CARRIER, MAINTENANCE, FULL TRACKED, FV434 MKS 1 AND 1/1

MODIFICATION INSTRUCTIONS AND INDEX

MODIFICATION INSTRUCTION NO. 1

SUBJECT: EMER TV E 107/4 Modification Instructions No. 1 to No. 27

Fig 2 Modification of BV tray

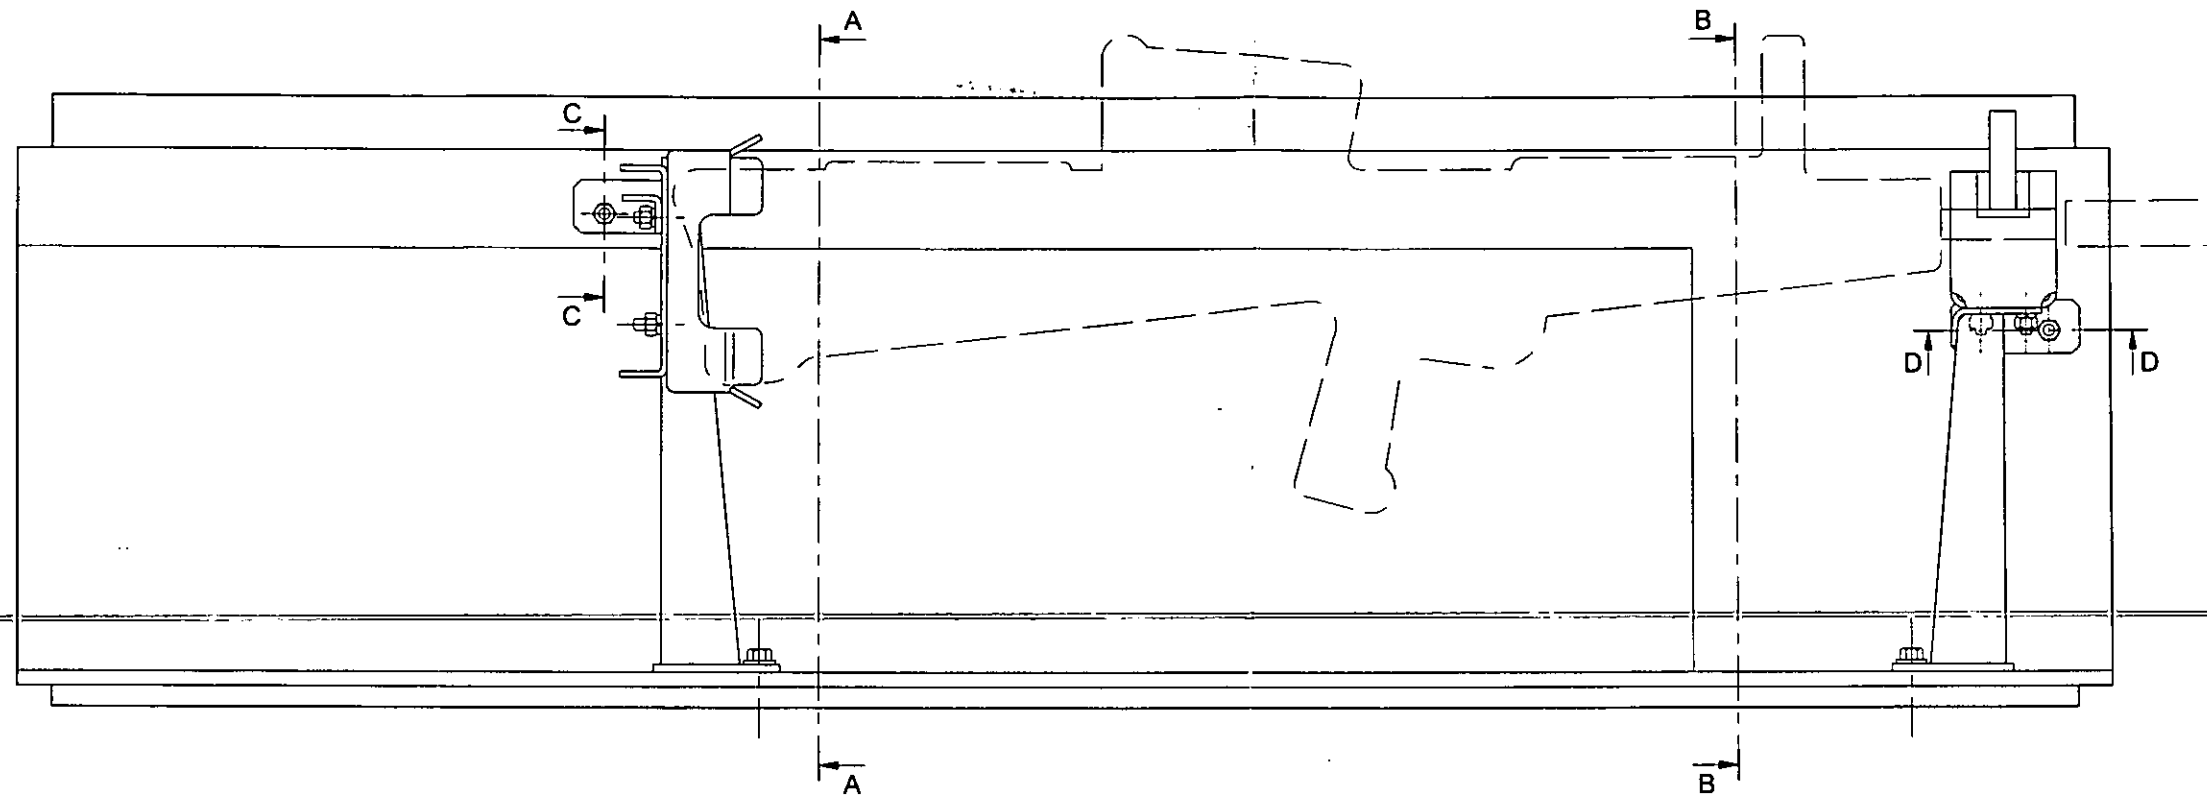
9.2 Remove and retain the BV tray (item 17) and fittings. Completely remove and discard both sections of the ammunition tray (item 18) from the engine cover.
